10.2 Turbine Generator

The information in this section of the reference ABWR DCD, including all subsections, tables and figures, is incorporated by reference with the following departures and supplements.

Figure 10.2-1 Turbine Stop Valve Closure Characteristic

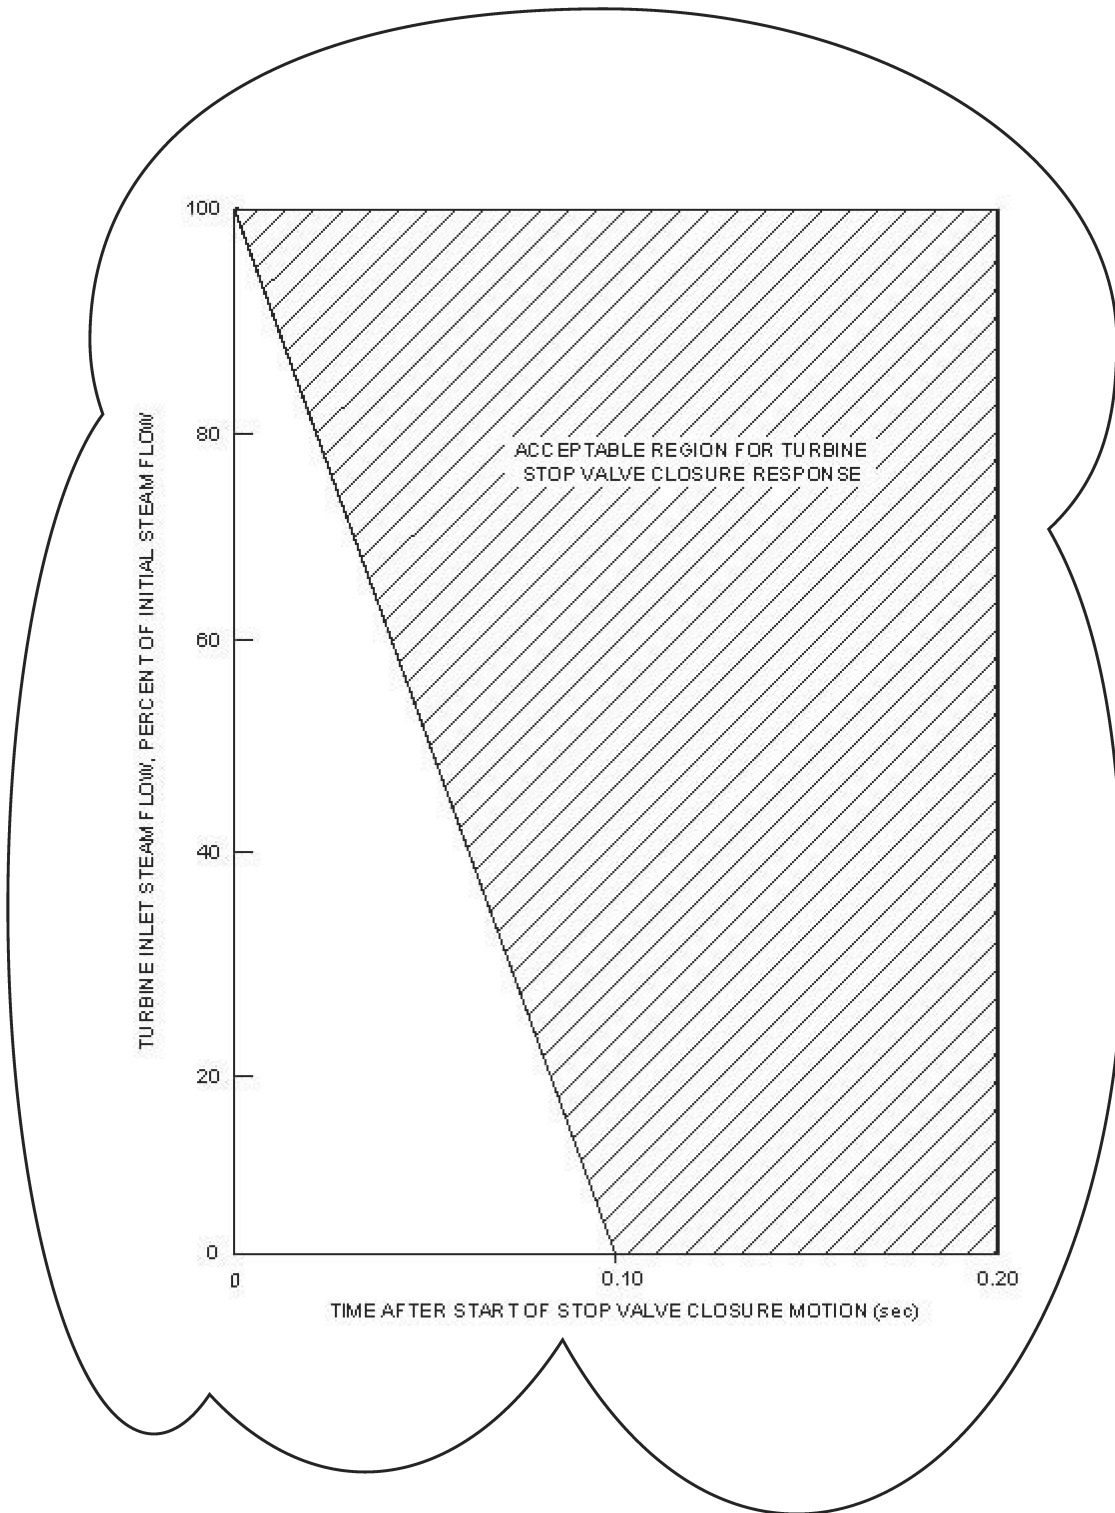
STD DEP Admin (Figure 10.2-1)

Figure 10.2-5 Turbine Overspeed Trip System Functional Diagram

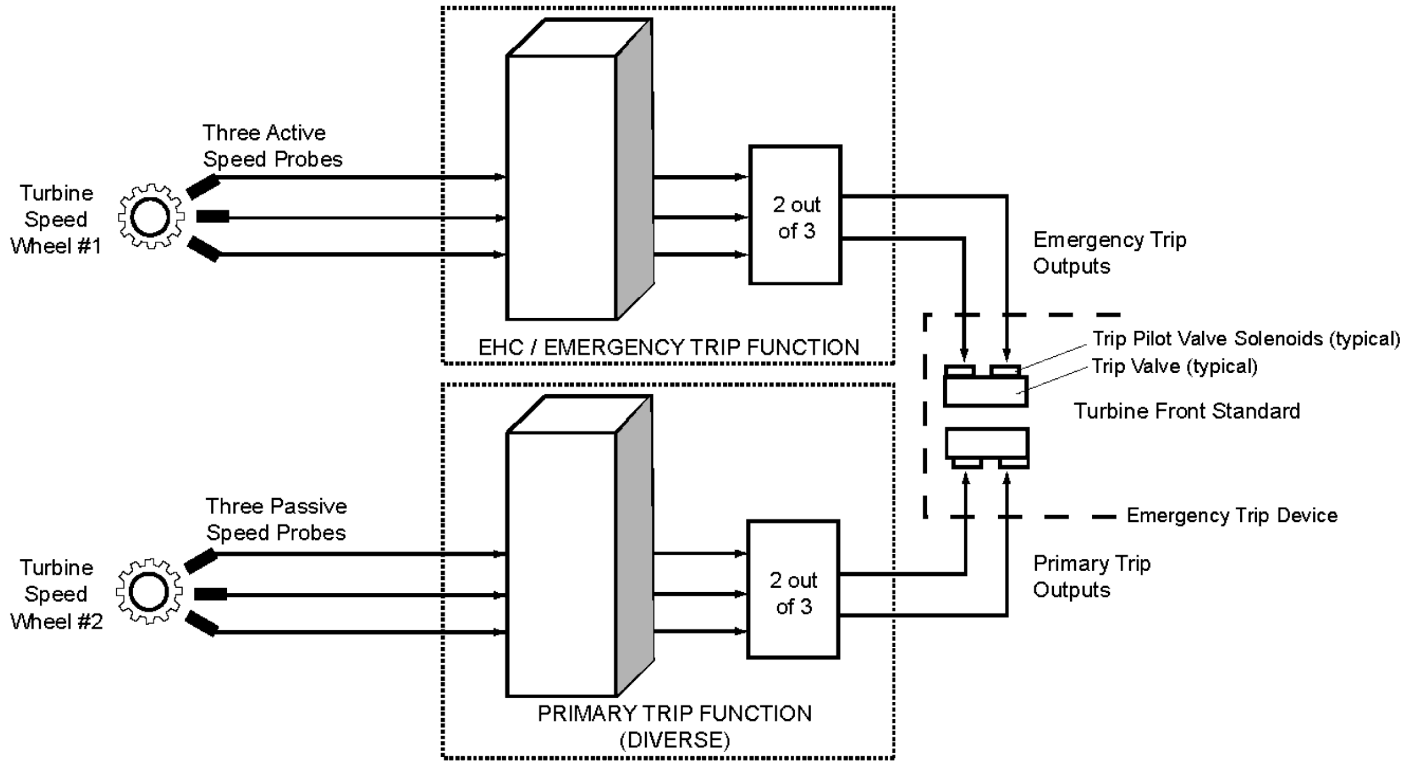
The primary trip function is independent and diverse from the emergency trip function as explained below (refer to Figure 10.2-5, Turbine Overspeed Trip System Functional Diagram). Two-out-of-three logic is employed in both the primary and emergency overspeed trip circuitry. Each trip function can de-energize its associated trip pilot valve solenoids of the electro-hydraulic Emergency Trip Device (ETD). The ETD is composed of two independent trip valves, each with two normally energized fail-safe solenoids. For each trip valve, each trip pilot valve solenoid is powered from a separate power source. The solenoids de-energize in response to detection of an overspeed condition by the turbine speed control logic. De-energization of both trip pilot valve solenoids is necessary to cause the spool in their respective trip valve to reposition, which depressurizes the emergency trip fluid system, rapidly closing all steam inlet valves and indirectly closing the steam extraction nonreturn valves. Accordingly, the repositioning of only one of the two trip valves is necessary to trip the main turbine. A single electrical component failure does not compromise trip protection, and does not result in a turbine trip. Each trip valve in the ETD is testable while the turbine is in operation.

and emergency overspeed trip functions also use separate speed wheels (refer to Figure 10.2-5). Each speed signal for the primary trip function is compared to a speed setpoint of approximately 110% of rated speed, and produces trip signals arranged in two-out-of-three logics, to de-energize both trip pilot valve solenoids of one of the two trip valves of the ETD. Both trip pilot valve solenoids must be de-energized to trip the associated trip valve. The ETD has two redundant trip valves. Tripping of either redundant trip valve will drain the emergency trip fluid, resulting in a turbine trip.
